STADIUM SCOREBOARD REPLACEMENT AT BUENA HIGH SCHOOL

BID # E8-24

ADDENDUM #02

Bid Addendum 2

AS-1.1

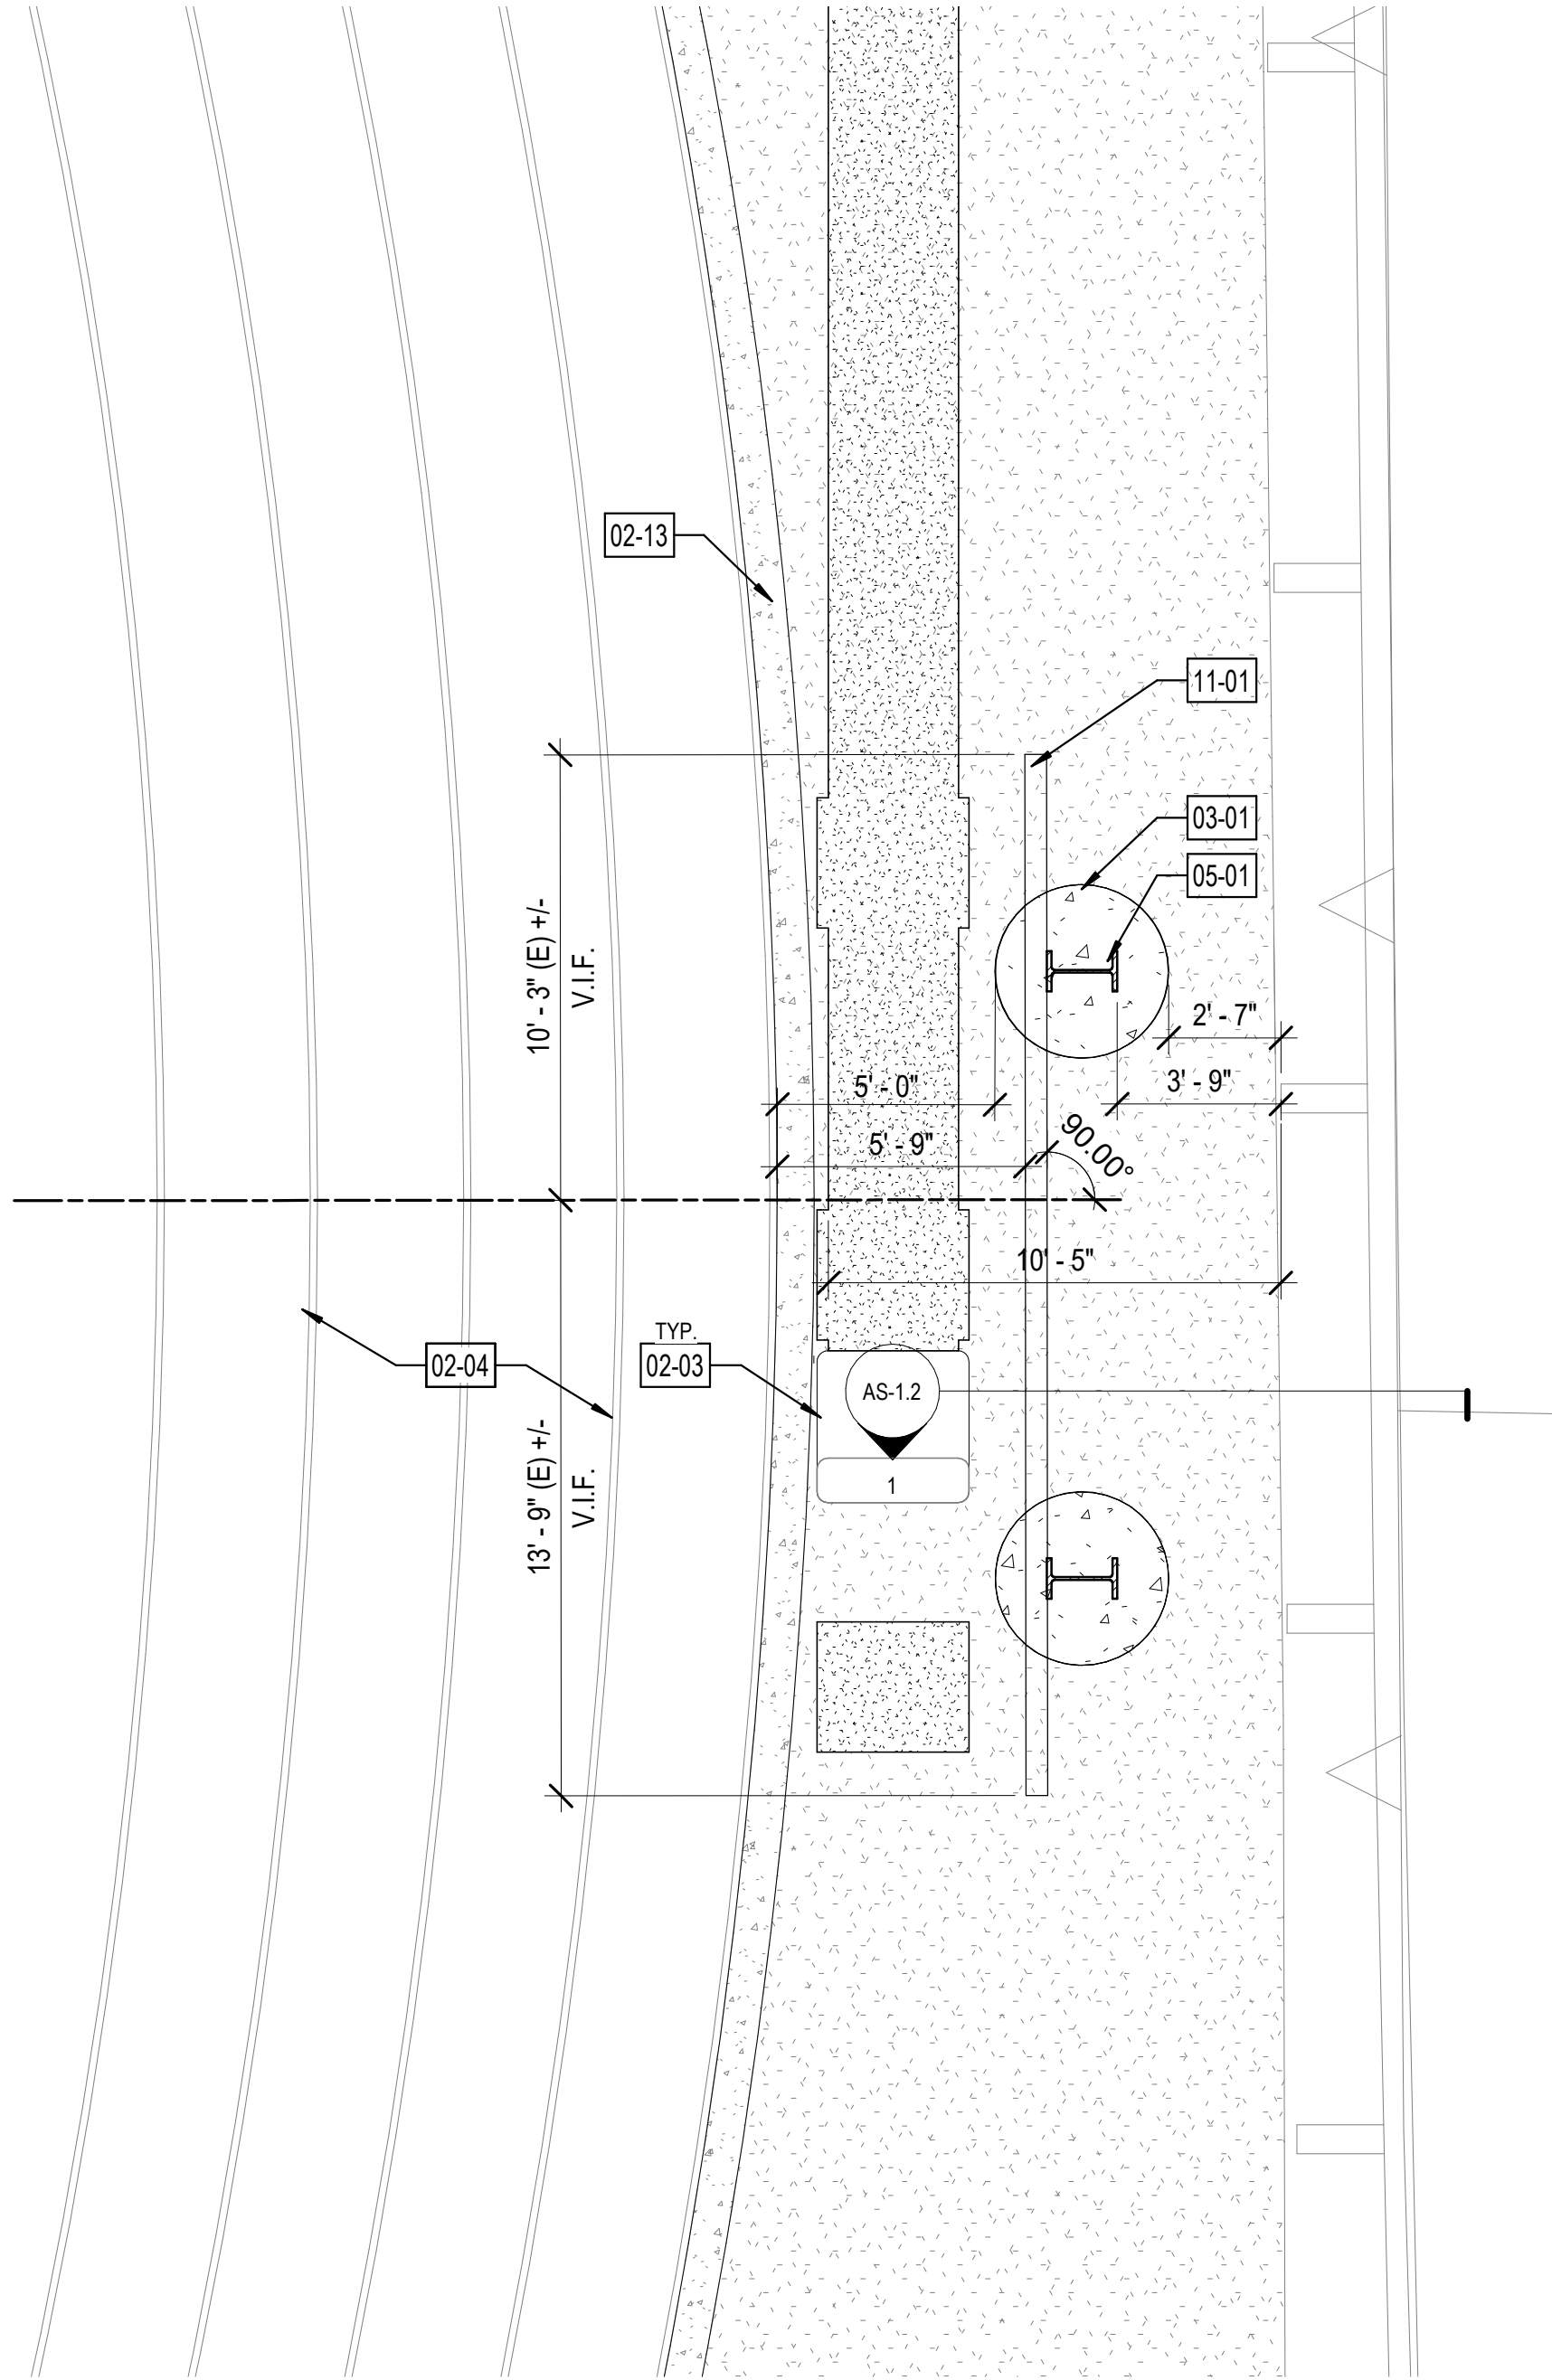
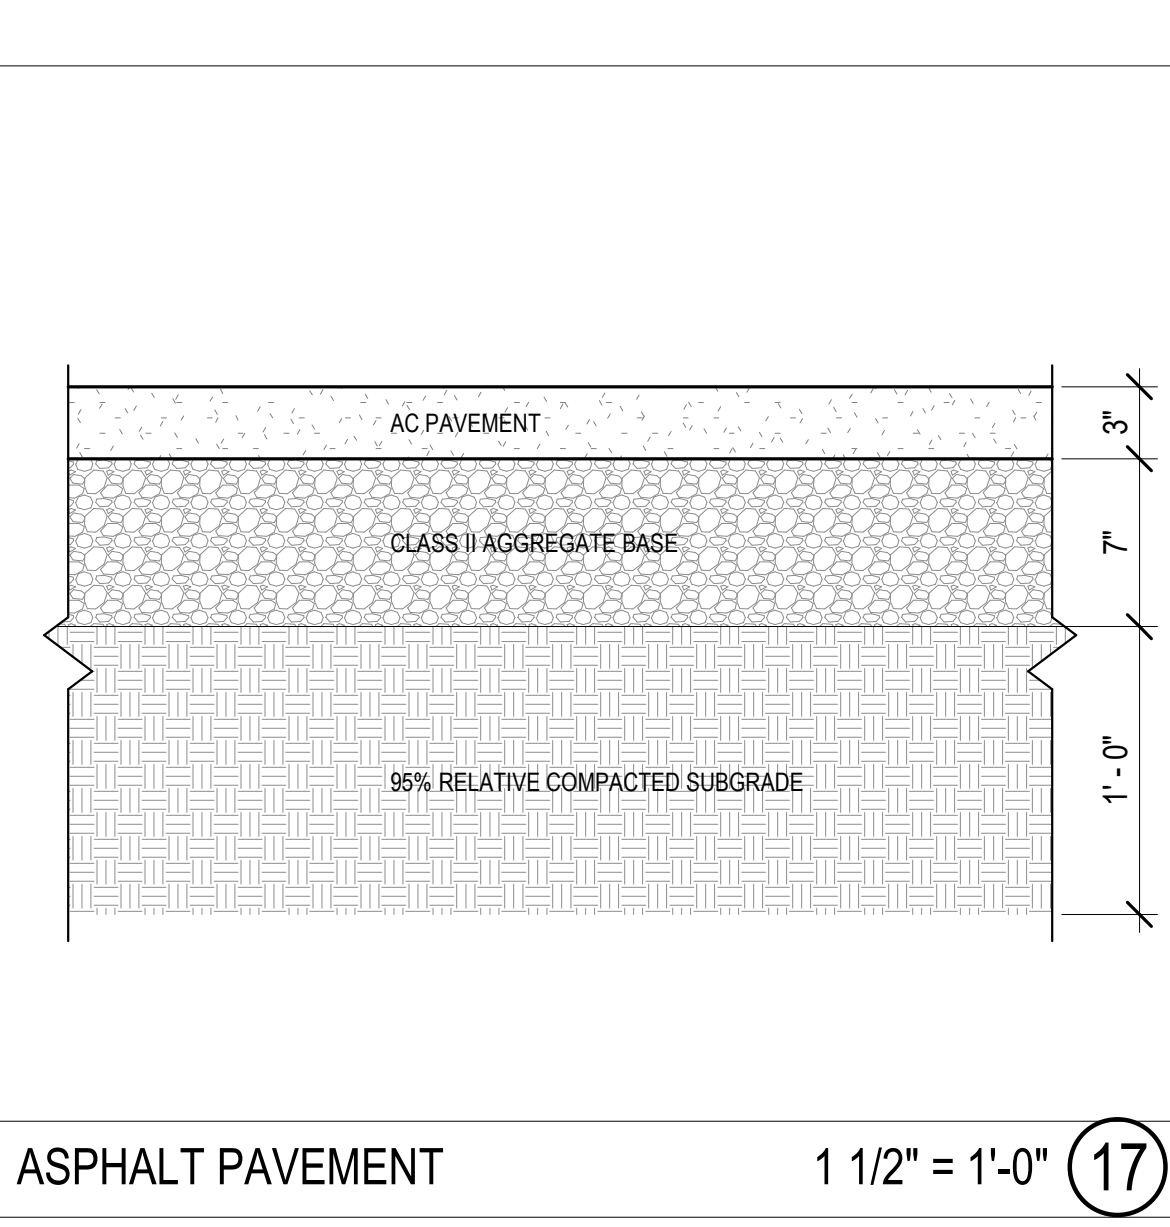
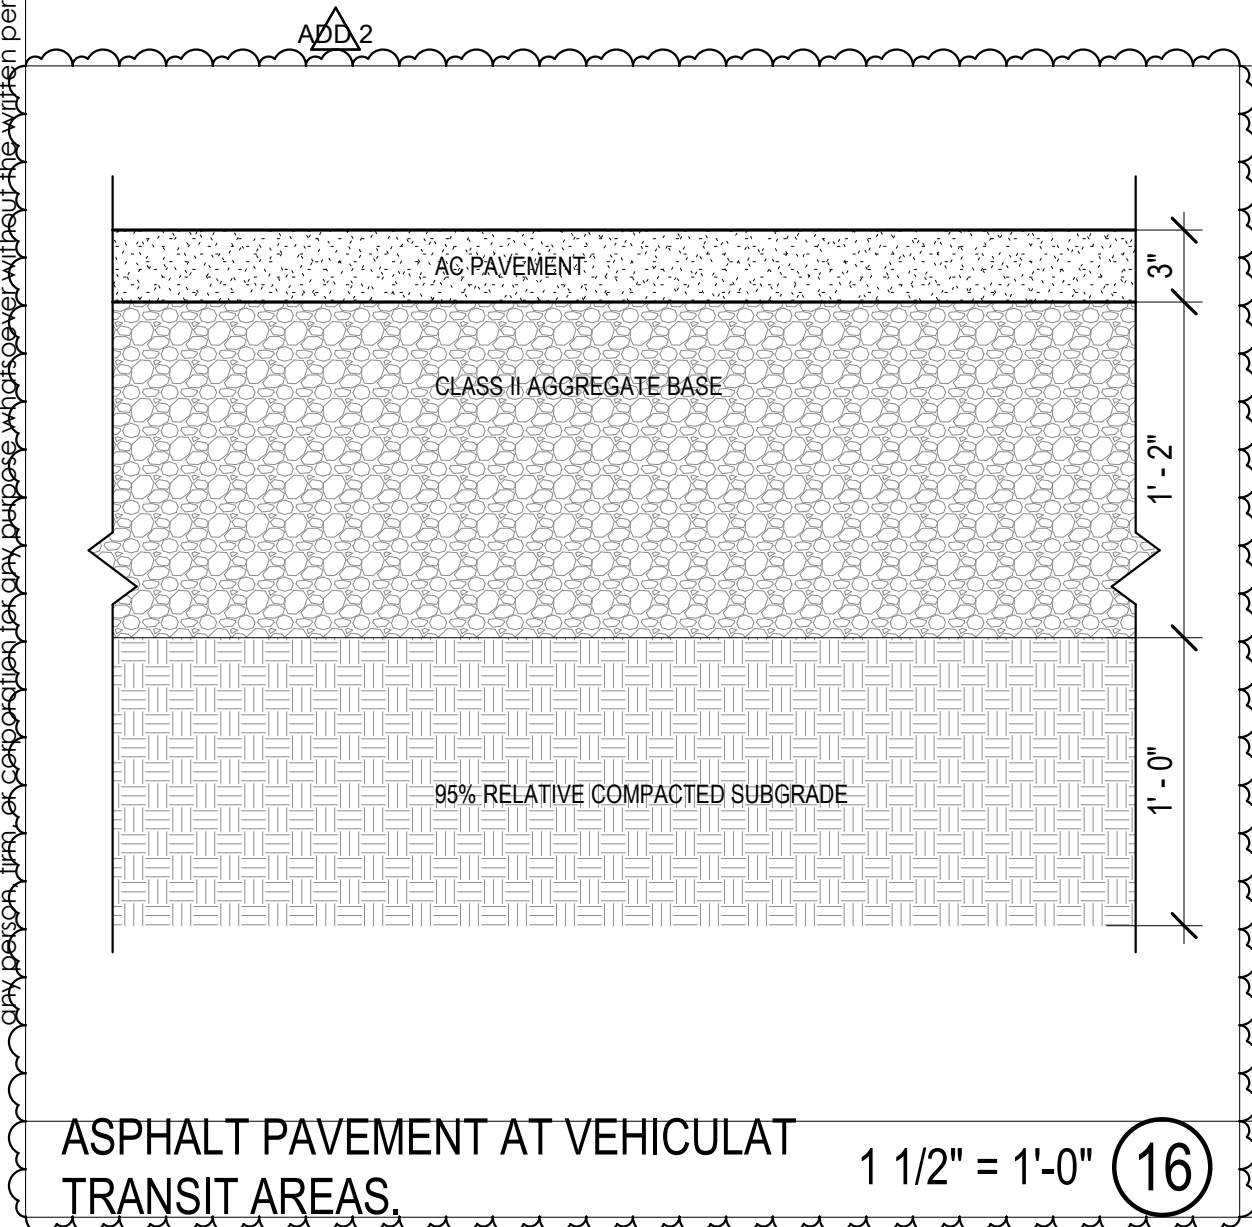
- Item 1.** AS-1.0: Rerouted trench for electrical conduit & added section of wall mounted conduit to existing maintenance building.
- Item 2.** AS-1.0: Added keynote 26-01.
- Item 3.** AS-1.0: Added new pullbox and keynote 26-02.
- Item 4.** AS-1.0: Added dim. note on asphalt area.
- Item 5.** AS-1.0: Updated trenching note on Legend.
- Item 6.** AS-1.1: Added detail 16.
- Item 7.** AS-1.1: Updated keynote 02-01.

EB-2.0

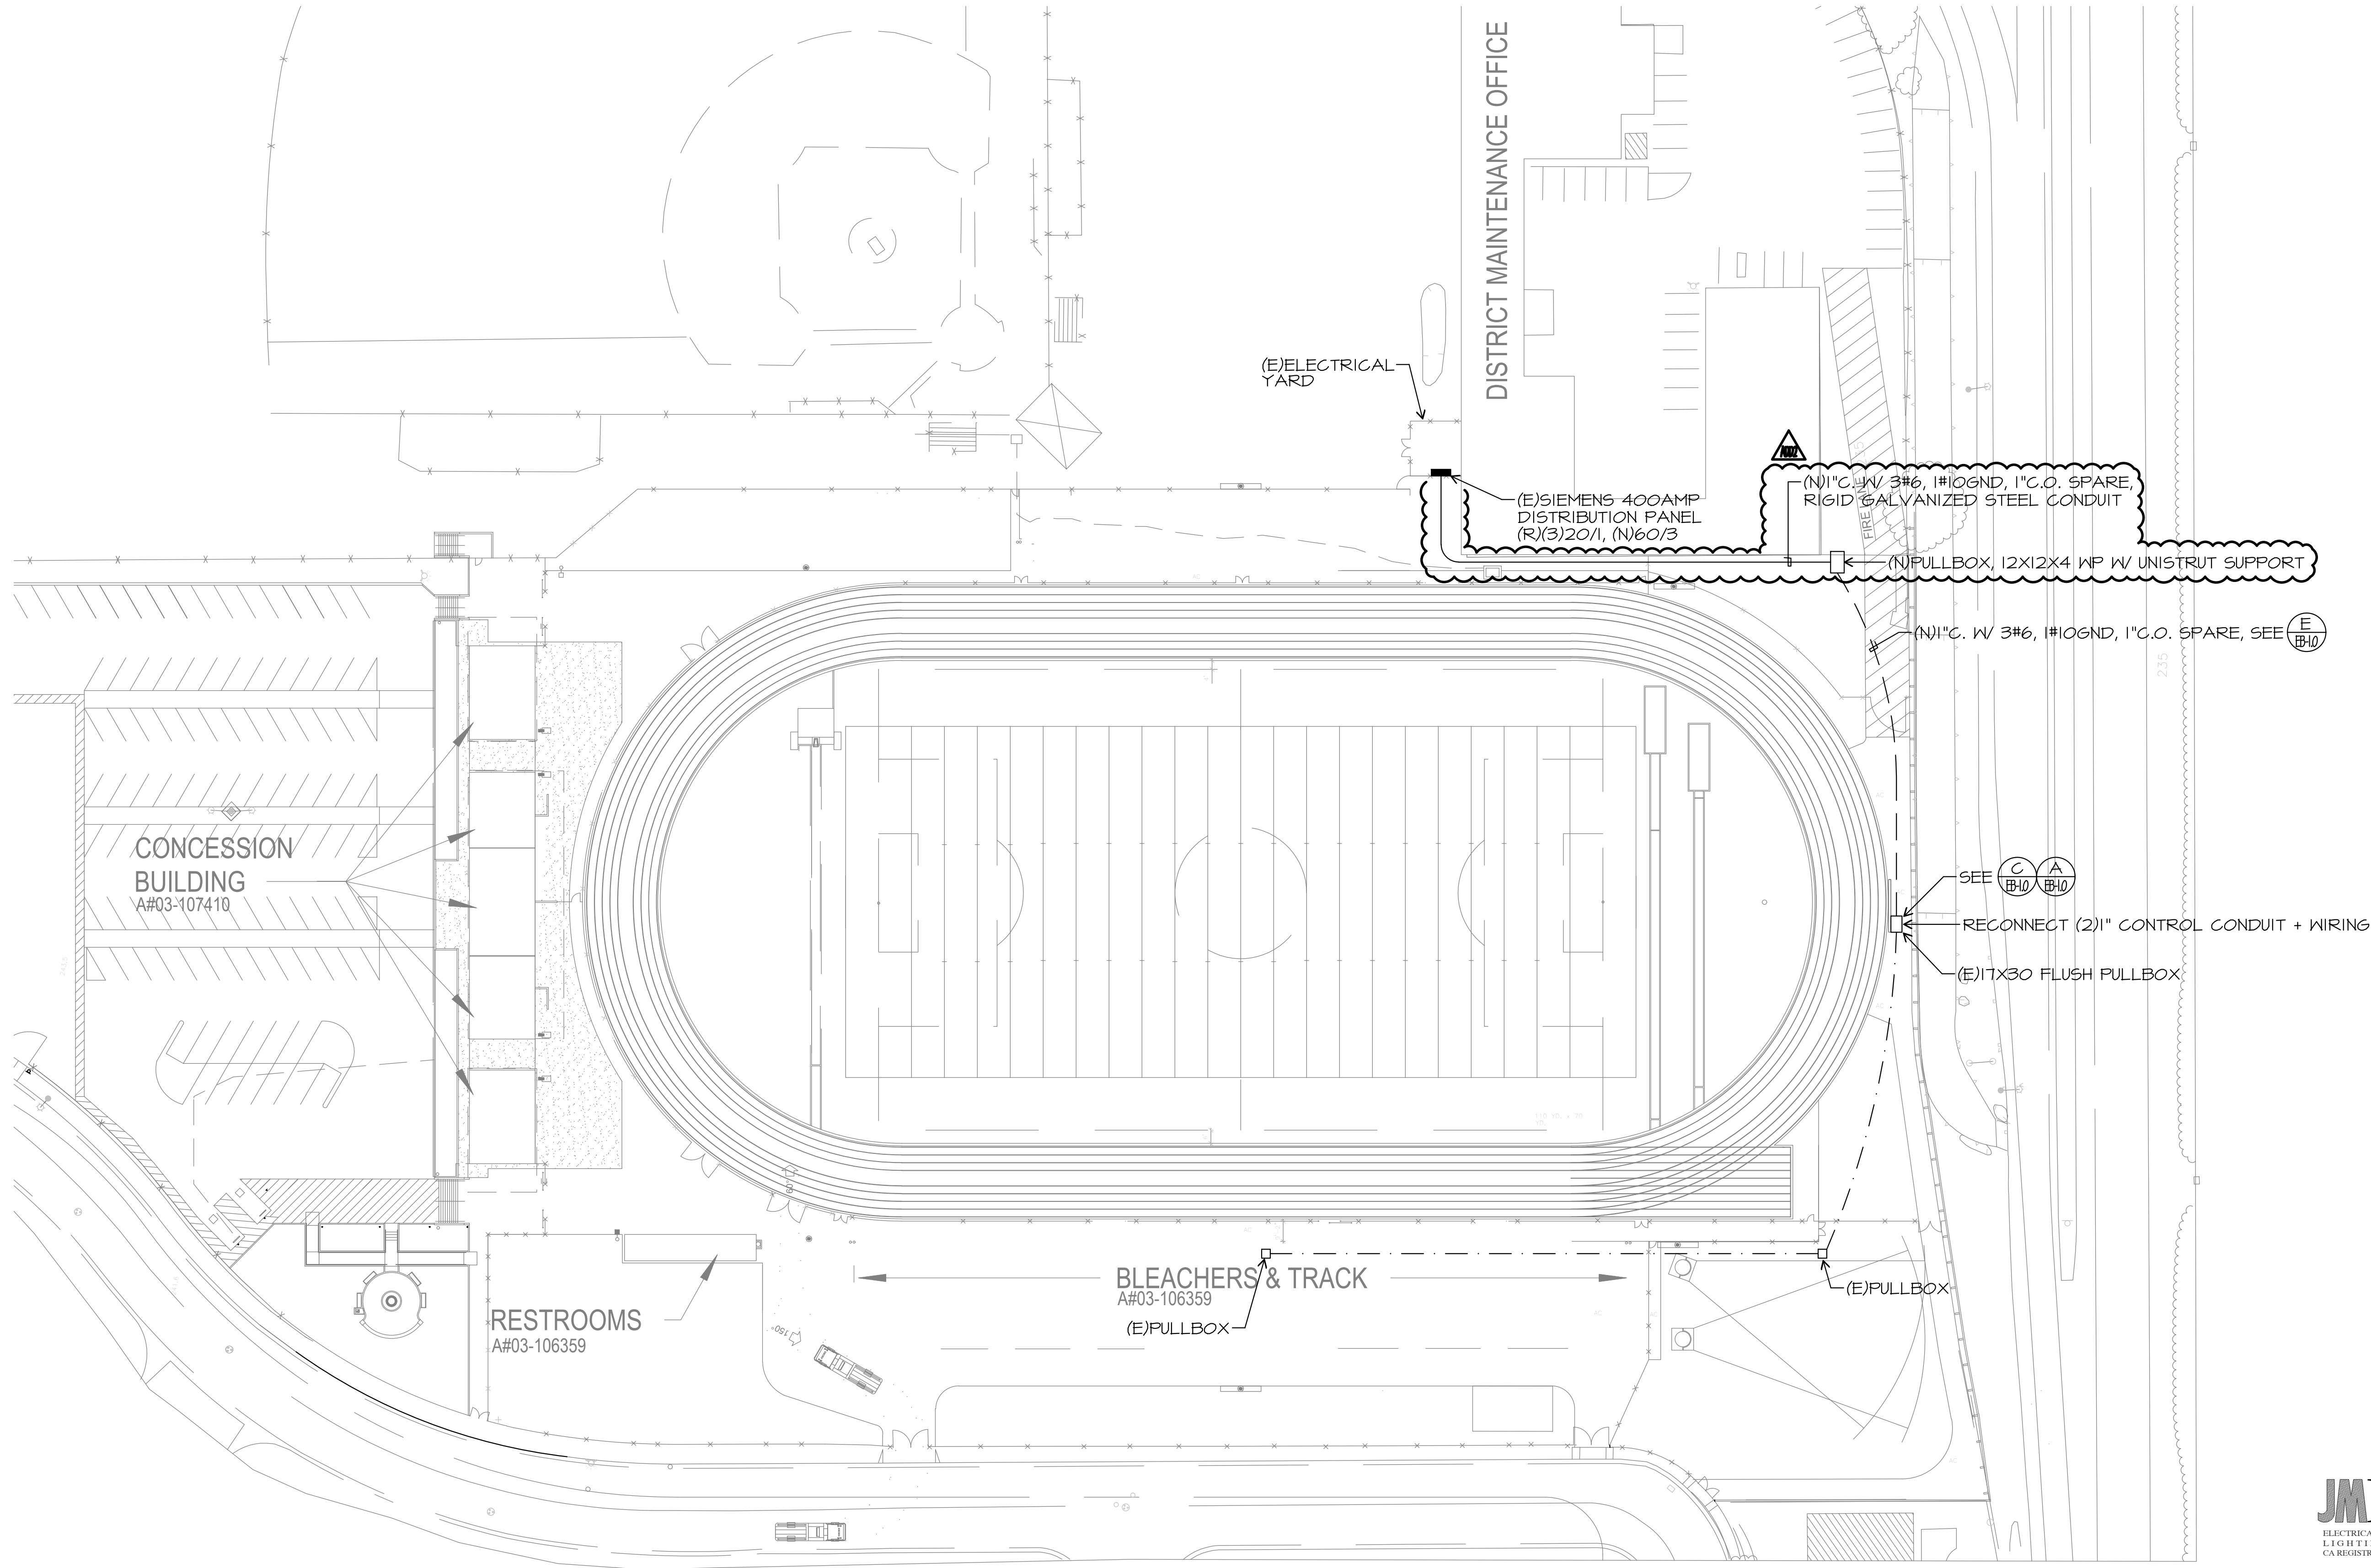
- Item 8.** EB-2.0: Rerouted trench for electrical conduit & added section of wall mounted conduit to existing maintenance building.
- Item 9.** EB-2.0: Added new pullbox.
